SAN JOSE CITY COLLEGE

FACILITIES MASTER PLAN ENVIRONMENTAL IMPACT REPORT COMMENTS AND RESPONSES

SCH# 1999-12-2011

**LEAD AGENCY: SAN JOSE EVERGREEN
COMMUNITY COLLEGE DISTRICT**

FIGURE 5.1-2

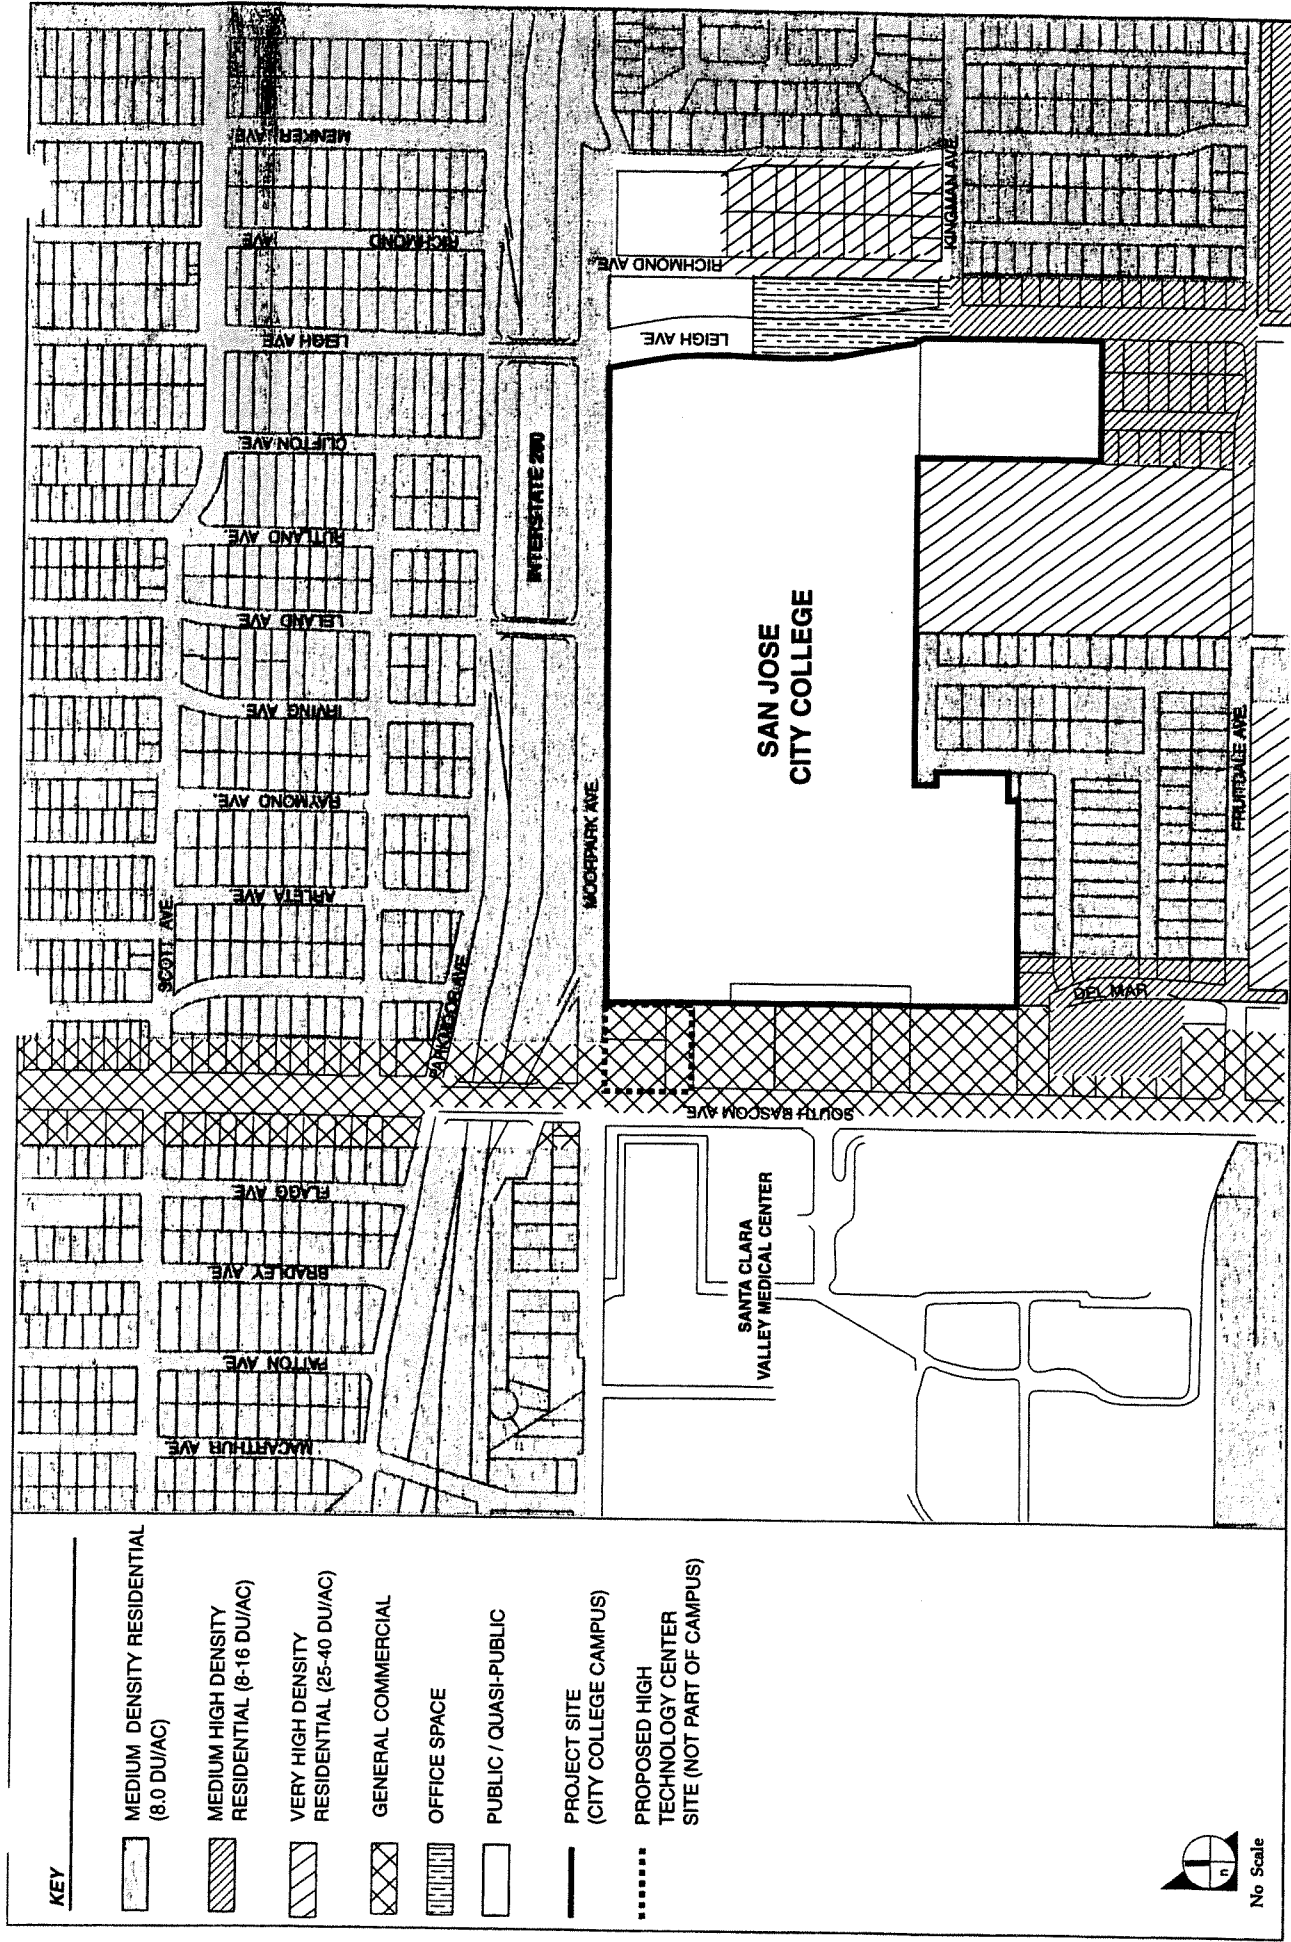
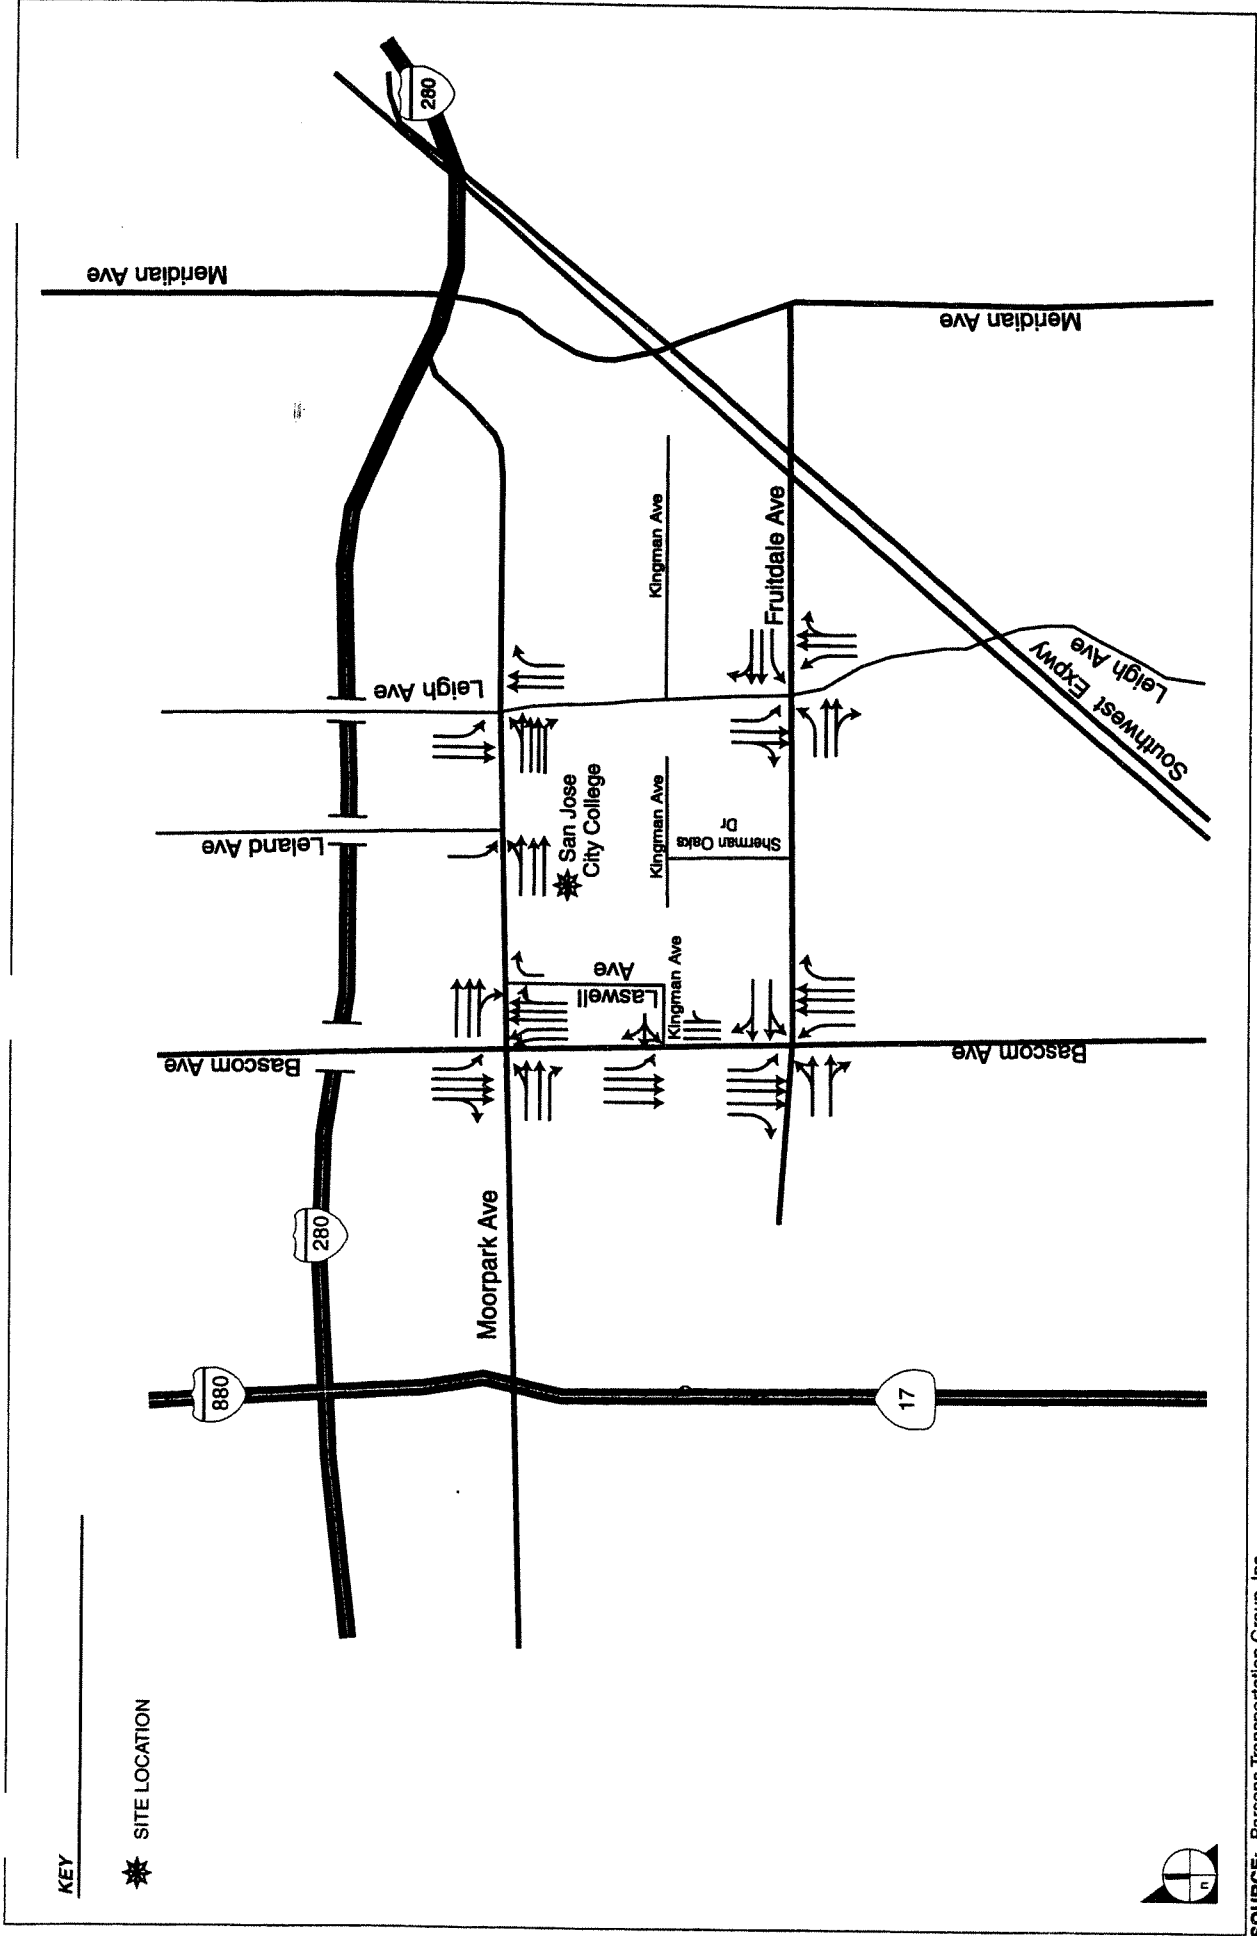
2. Please provide the lane configuration at the intersections of Bascom Avenue/Kingman Avenue and Laswell Avenue/Moorpark Avenue. Please also include a lane geometry figure for the project condition. (A-2)
3. Please include a freeway segment analysis for the "Near-Term Cumulative" and "Far-Term without Master Plan Buildout" conditions. (A-3)
4. The methodology used in calculating the freeway level of service (LOS) for all conditions except the existing condition should be included in the traffic analysis. (A-4)
5. Please include a ramp analysis and weaving analysis (if applicable) for all scenarios. (A-5)
6. All ramp terminus intersections that will be impacted by this project should be analyzed. (A-6)

- A-2. The lane configuration figure has been updated and is included at the end of this chapter. For purposes of this traffic study, guidelines set forth by both the City of San Jose and the Santa Clara Valley Transportation Authority's (VTA) Congestion Management Program (CMP) were adhered to. Neither required a lane configuration figure other than for Existing Conditions.

FIGURE 5.1-6

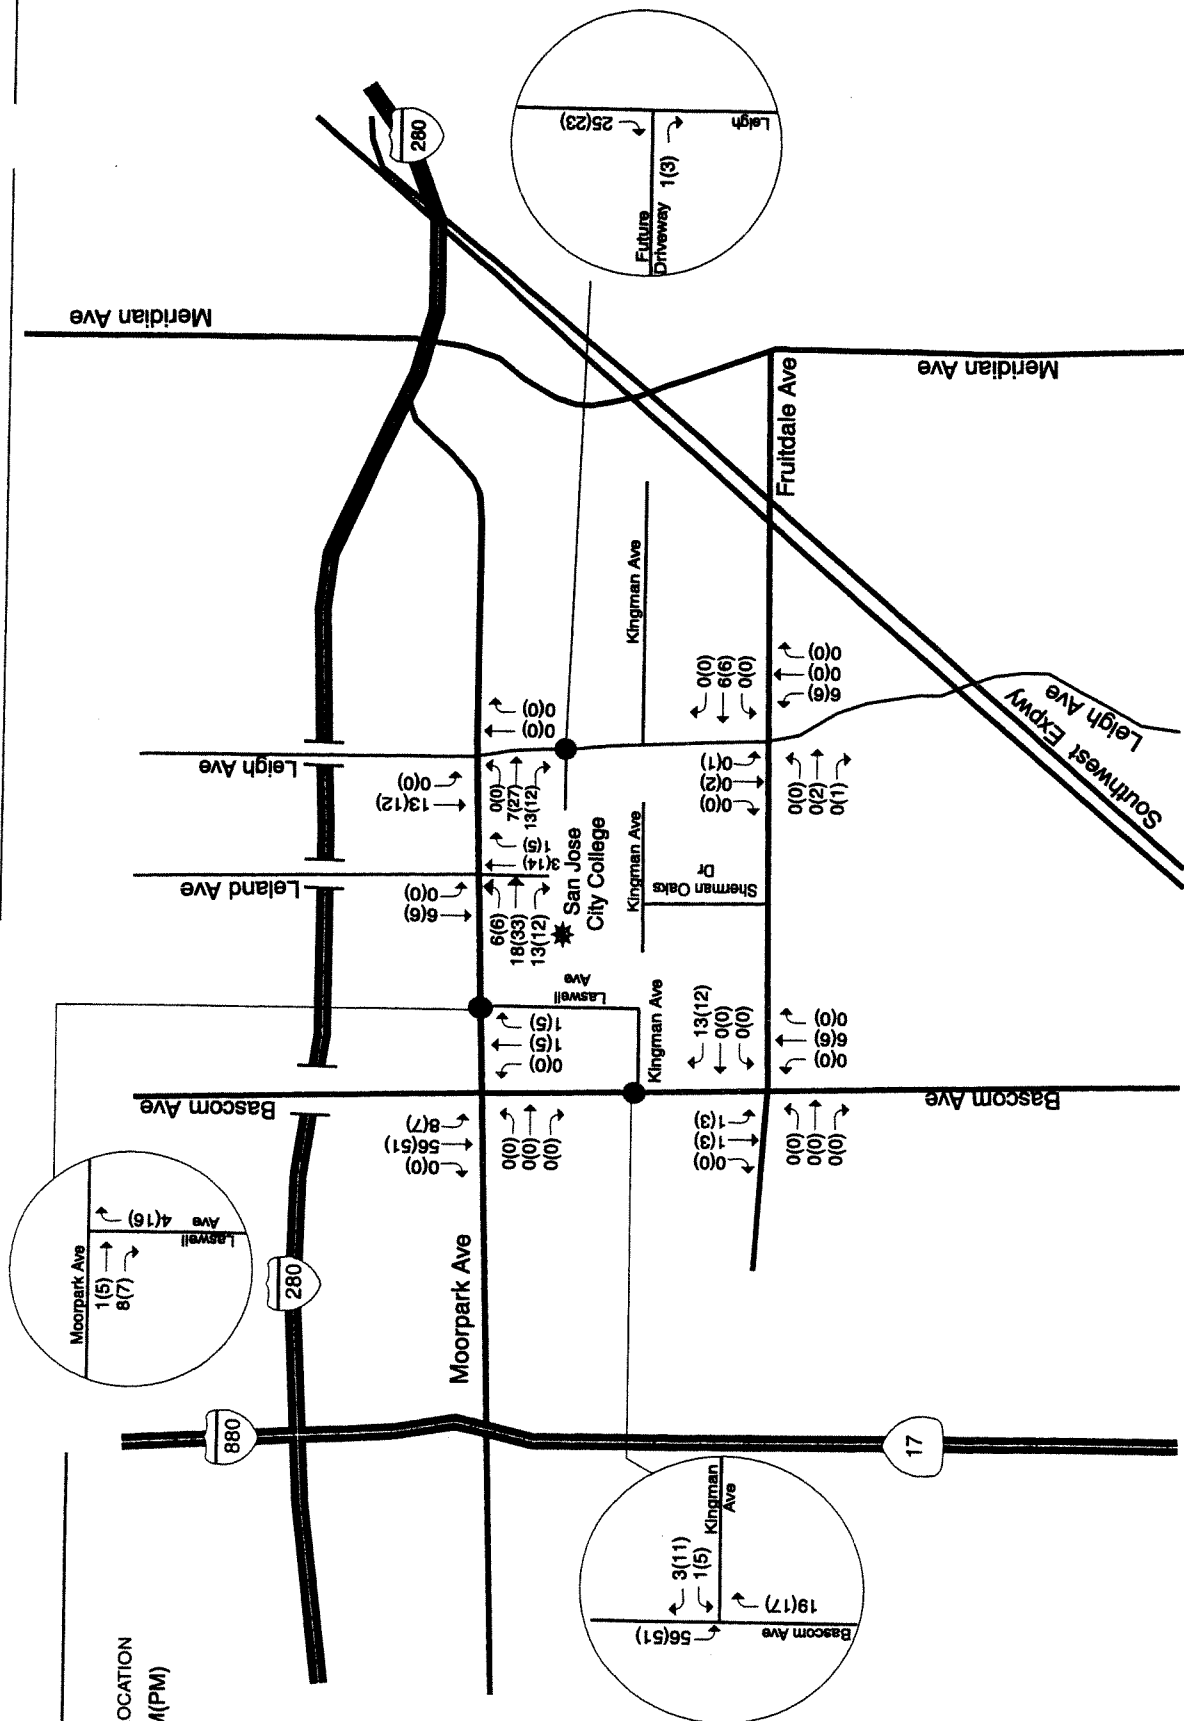
1. The Traffic volumes shown in the figures do not match the volumes used in the Traffix analysis. For example, Figure 5.1-6 shows the eastbound project trip assignment on Moorpark Avenue at Leland Avenue under Near-Term Project condition is 18 for the AM peak period. But a total of 1,008 trips was coded for the eastbound movement in the analysis with 41 trips (i.e., $1,008 - 967 = 41$) as the project trip assignment. (A-1)

Also, some of the movements coded in the Traffix analysis were not shown in the figures. For example, northbound through movement at the intersection of Moorpark Avenue and Leland Avenue was coded in the Traffix analysis but not shown in Figure 5.1-6.

- A-1. Updated figures are presented at the end of this chapter. The results of the analysis (level of service) presented in the Draft EIR are based on the Traffix numbers, and those numbers are not affected by the revisions.
